CITY OF CONWAY, ARKANSAS HISTORIC DISTRICT COMMISSION

HISTORIC DISTRICT COMMISSION

A. New single-family residence at 346 Ash St (HDR-0125-0002) **Old Business**

B. New office building with associated parking at 1140 Harkrider St (HDR-0225-0016)

A400

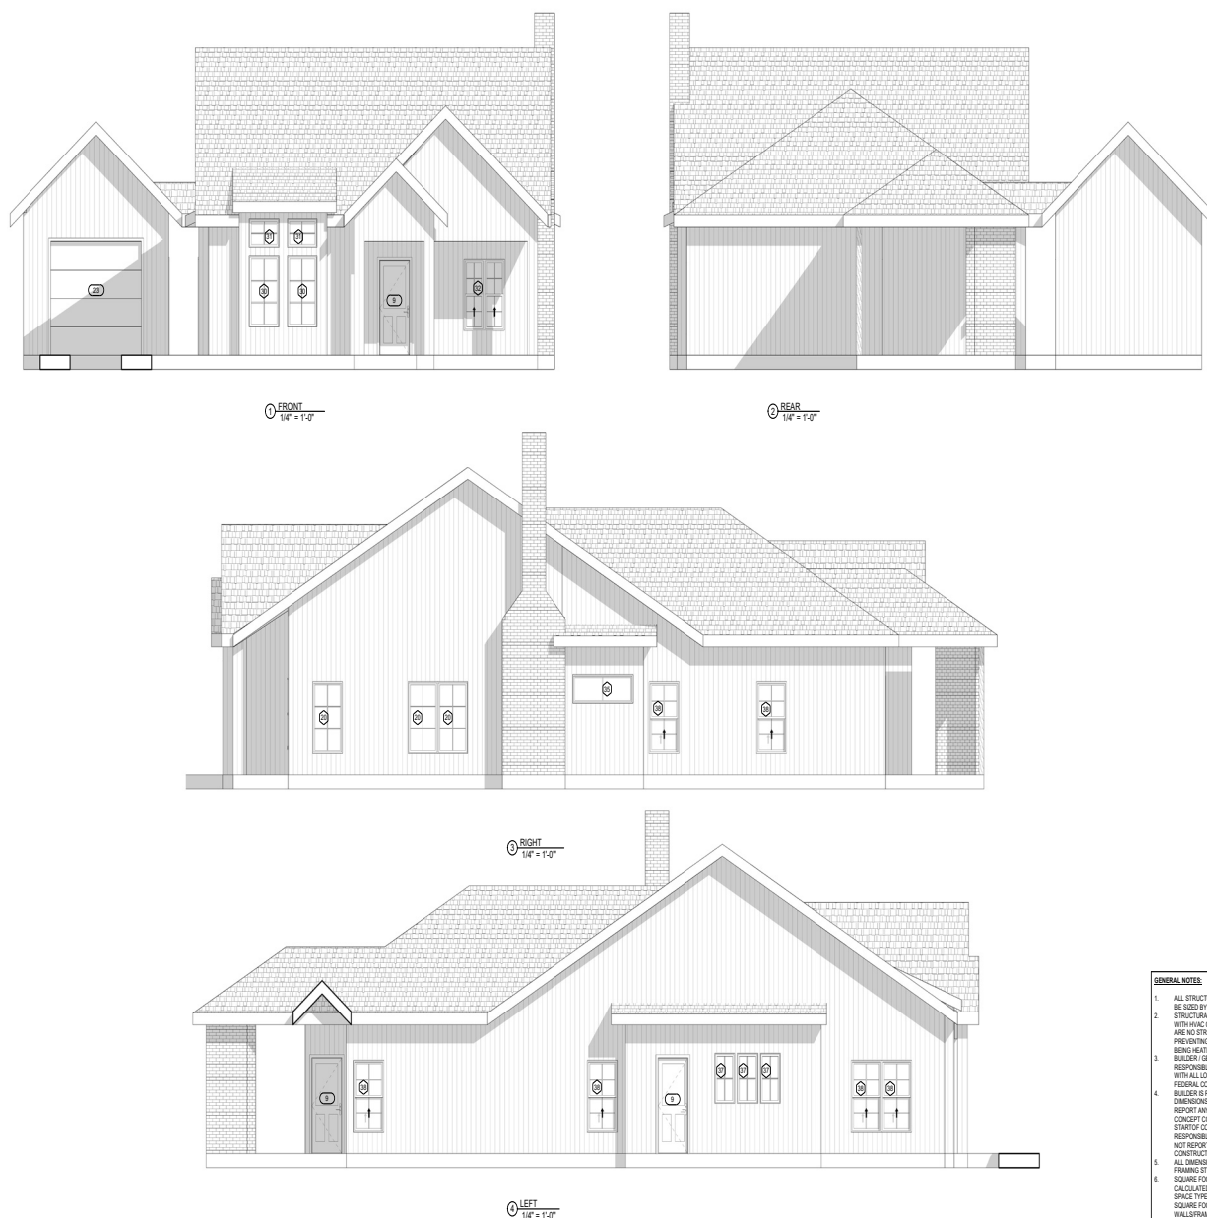
The rear elevation lacks windows at the location of the laundry room, master closet and one bedroom. This elevation faces an empty lot owned by Central Baptist University. The rear elevation of the proposed residence is visible from Center Street.

SITE PLAN

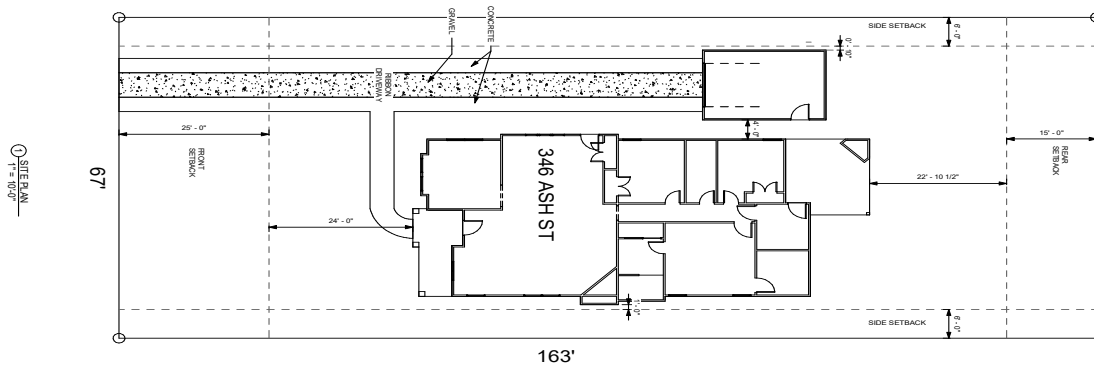
The predominant front setback is 25' from right-of-way. The applicant is proposing a setback of 49'. This is in excess of the average for the area. Right-of-way does not appear to have been dedicated yet. The front setback needs to be between 20 and 30 feet from right-of-way.

Northern side yard abuts a 10' alley. The proposed garage is 6' from the side yard which equates to 11' from the centerline. The eastern side yard setback conforms to 6'. The rear setback conforms.

The applicant has indicated a driveway off Ash St. near the northern property line. Concrete driveway strips are proposed. It appears to be about 10' wide and terminates at the attached garage.

No HVAC equipment is shown on the site plan.

4. Prior to issuance of a Certificate of Appropriateness, applicant shall submit for review by Planning & Development staff a site plan showing:
 - Appropriate front and side yard setbacks.
 - Lot coverage tabulation with driveway and internal sidewalks.
 - Tree removal, retention and plantings.
 - Sidewalks and greenspace in right-of-way.
5. Driveway shall be concrete, pavers, or permeable paving.
6. A 5' sidewalk with 6.5' greenspace is required.
7. Lighting shall be downward and inward toward the property.
8. HVAC equipment shall be screened from public view.

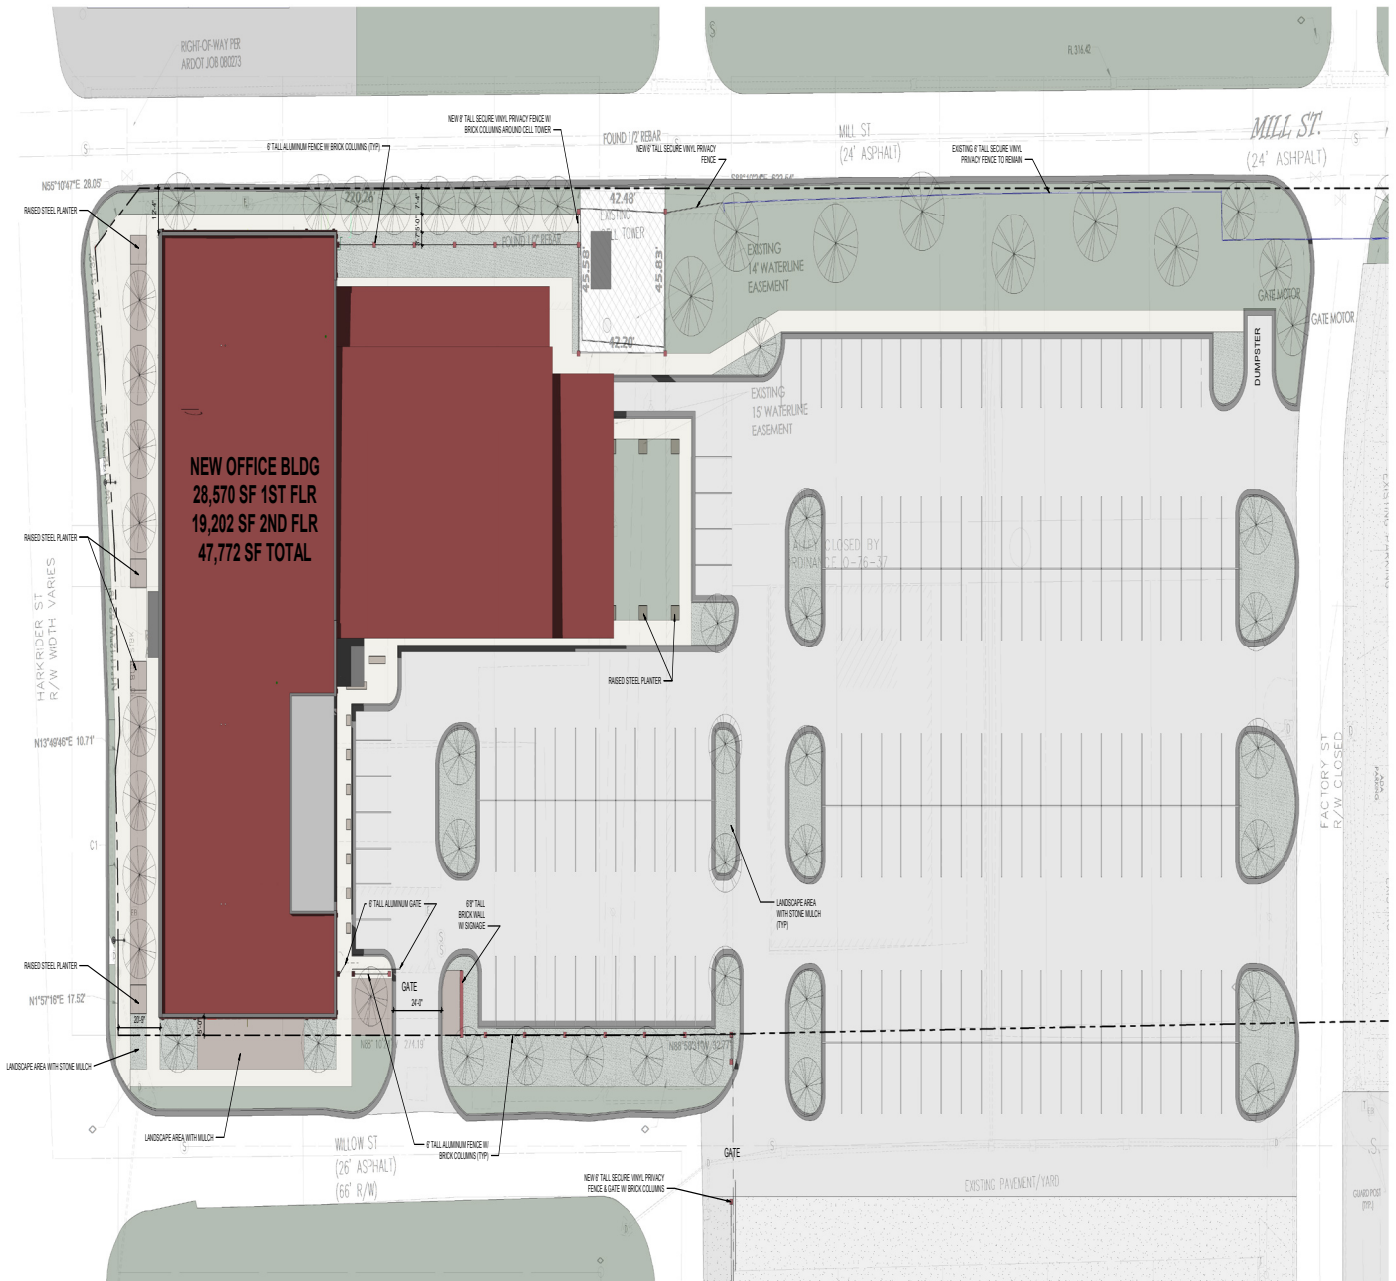
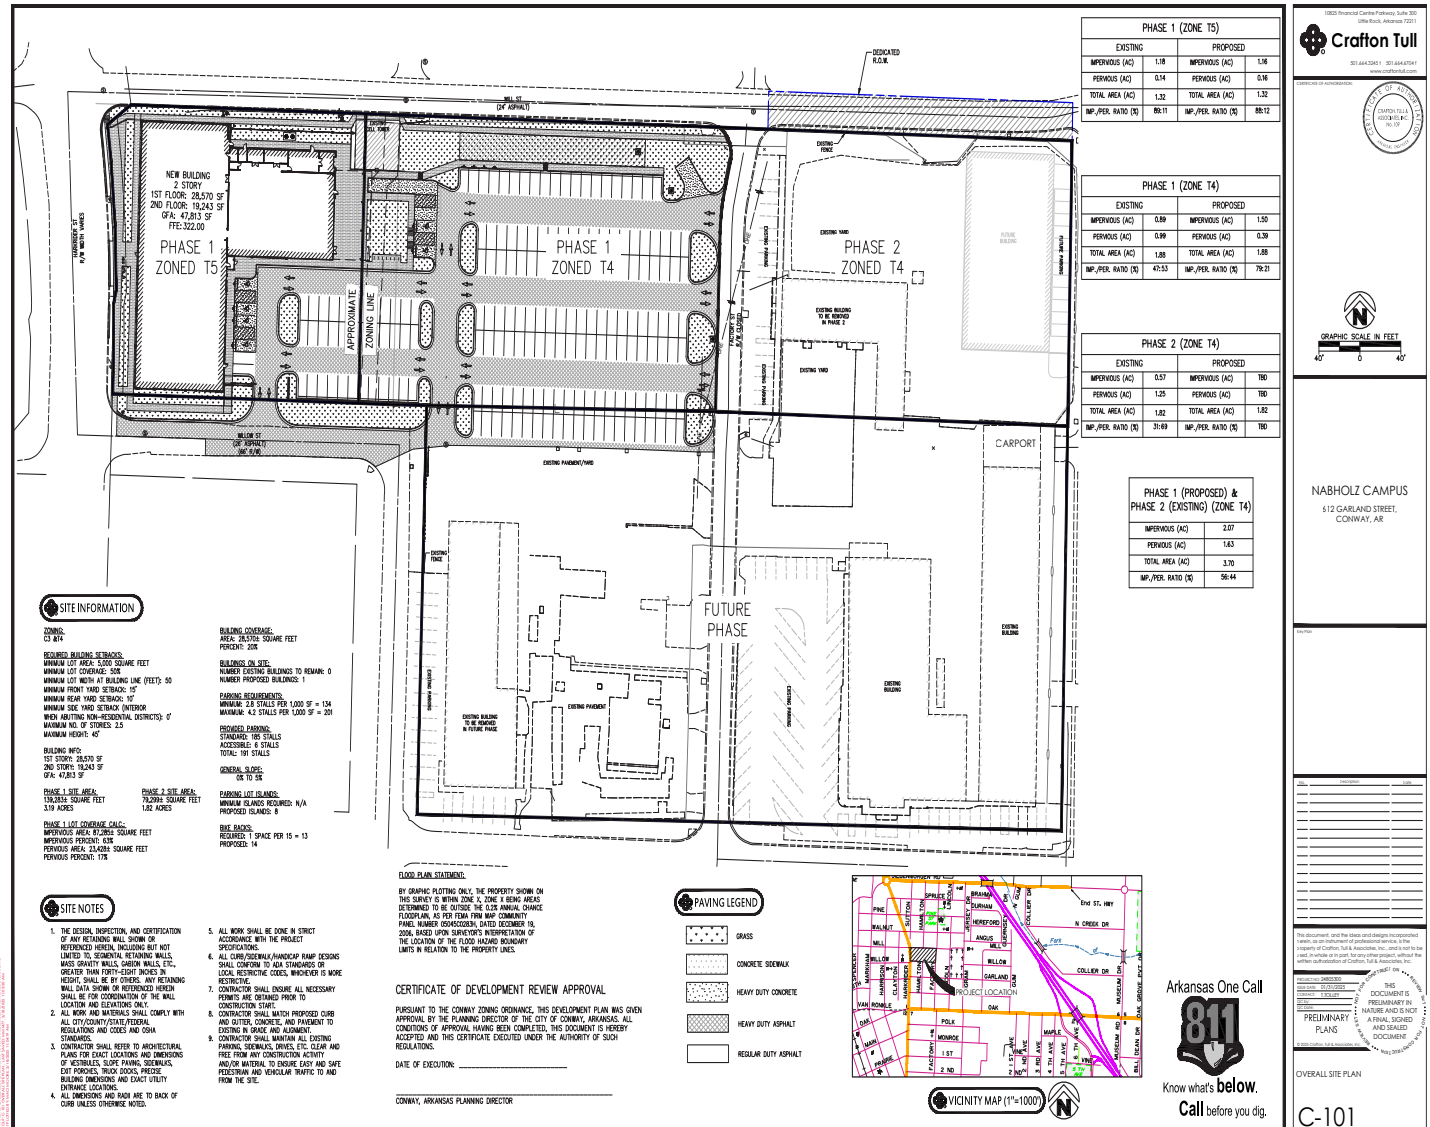
The site plan is showing a 20' front yard setback, a 12'4" setback to Mill St along one plane, and does not specify the setback along the entire Mill St elevation. The Willow St elevation shows a 5' setback. Setbacks do not conform. This phase of the project is currently in a minor subdivision review. Right-of-way and property lines are uncertain. Through the plat review process, any issues should be reconciled. The applicant has shown greater than required setbacks to account for any movement of property lines. An updated site plan will need to be submitted for staff review once the plat has been filed.

A 6' tall steel fence with brick columns is proposed along Willow St. A 6' tall vinyl privacy fence and gate with brick columns is proposed along Hamilton St. The existing 6' tall vinyl privacy fence along Mill St is proposed to remain (along the parking area). Steel and brick meet the Urban Zone standards. The vinyl fence is not in conformance with standards in the Urban or Suburban Zones. It is not proposed to be 70% open. The applicant has expressed that its existence is for security purposes as the site contains construction equipment. Should the HDC approve the fence as currently proposed, it is recommended that any visual impact be mitigated through landscaping.

A 24' wide driveway is proposed along Willow St and the width of the curb cut not specified. All other entrances are along a private driveway. No access is proposed off of Harkrider.

There is an existing sidewalk along Harkrider St and portions of the Willow St frontage are paved. There is no sidewalk along Mill St and the current structures (to be demolished) are located in ROW. A proposed sidewalk is shown outside of ROW along portions of Mill St and in ROW along a portion of Willow St. The sidewalk proposal terminates at the cell tower on Mill St. The sidewalk should extend outside of ROW along Mill St and on Willow St. Standard details call for a 10' wide sidewalk with 7.5' of greenspace on Harkrider and a 5' sidewalk with 6.5' of greenspace along Mill St and Willow St. Sidewalks location and configuration will be reviewed on plat and construction enforced during SDR and building permit issuance/final.

6. Fencing shall be removed from right-of-way. Landscaping shall be provided between the Mill St fence and the street.
7. Prior to issuance of Certificate of Appropriateness, applicant shall submit for review by planning staff a site plan and elevations showing:

- Structures built to appropriate setbacks.
 - Sidewalks and greenspace as described in #4.
 - Landscaping to the north of the fence along Mill St.
 - Material percentage breakdown to ensure compliance with standards.

1 HARKRIDER ELEVATION
SCALE: 3/32" = 1'-0"

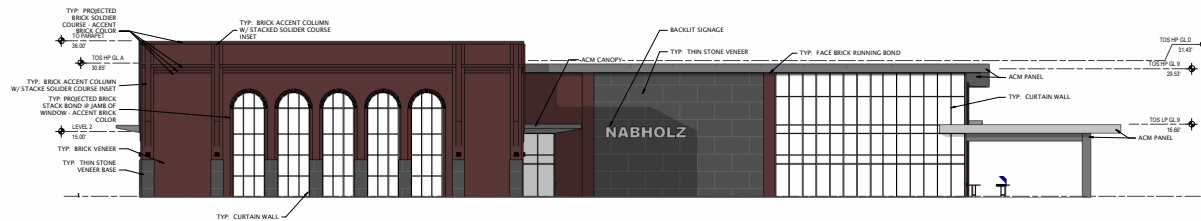
The proposal meets all of the above standards except that the first story windows are not 3' above the ground level.

Overhead covers composed of ACM are shown on the internal elevation and the Willow St entrance. One may be shown on the Harkrider St elevation, but it is not called out.
